<b>DOCKETED</b>	
<b>Docket Number:</b>	19-IEPR-01
<b>Project Title:</b>	General/Scope
<b>TN #:</b>	227198
<b>Document Title:</b>	Alliance for Nuclear Responsibility Comments CEC review of expedited transfer of Diablo Canyon spent nuclear fuel to dry cask storage
<b>Description:</b>	N/A
<b>Filer:</b>	System
<b>Organization:</b>	Alliance for Nuclear Responsibility
<b>Submitter Role:</b>	Public
<b>Submission Date:</b>	2/28/2019 8:47:46 PM
<b>Docketed Date:</b>	3/1/2019

## **CEC review of expedited transfer of Diablo Canyon spent nuclear fuel to dry cask storage**

**ALLIANCE FOR NUCLEAR RESPONSIBILITY'S  
PROTEST**

**FIGURE 6-2  
SPENT FUEL POOL OFFLOAD EXAMPLE  
COMPARING PRE-SHUTDOWN VERSUS POST-OFFLOAD<sup>15</sup>**

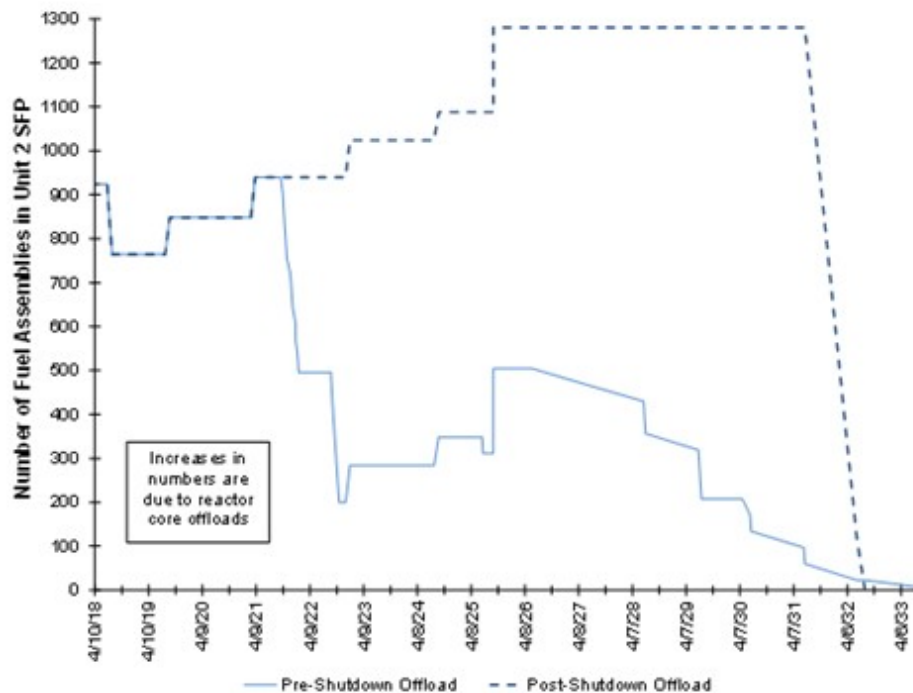
PG&E's 2018 NDCTP testimony provides the following graphic illustration of the impact on the number of spent fuel assemblies in the Unit 2 pool under what PG&E labels a "Pre-Shutdown Offload" versus a "Post-Shutdown Offload":

While the variance between the two lines on PG&E’s graph is stark, even greater perspective on the significance of PG&E’s new strategy can be gained from past reference points:

- CEC 2008 target (original design capacity before re-racking): 270<sup>16</sup>
- October 2011 inventory reported by PG&E to DCISC: 1,096<sup>17</sup>
- DCISC 2013 then-current estimate: ~1,024<sup>18</sup>

- PG&E’s 2014 announced target to achieve in 2016: 736<sup>19</sup>
- June 2016 inventory on day Joint Proposal announced: 1,032<sup>20</sup>
- January 2017 CEC understanding of PG&E’s then-current “plan”: 772<sup>21</sup>

PG&E was ordered by this Commission to file with its 2017 general rate case a satisfactory plan to implement the CEC’s Assembly Bill 1632 Report recommendation (“return ... to open racking arrangements as soon as feasible, while maintaining compliance with NRC cask and pool spent fuel storage requirements”). Instead of complying, PG&E entered into a settlement agreement (and a Joint Proposal) which obligated it to “collaborate” and “coordinate” with the CEC. PG&E chose to ignore that obligation and instead has embarked upon a course to **increase** its dependence on wet storage far beyond the levels that triggered the CEC recommendation in 2008; the post-Fukushima concerns of Senator Feinstein, the Board of Supervisors, and the local newspaper in 2011; and even the utility’s modest targets of 2014 and 2016. **And the company intends to maintain these elevated levels until 2032.**
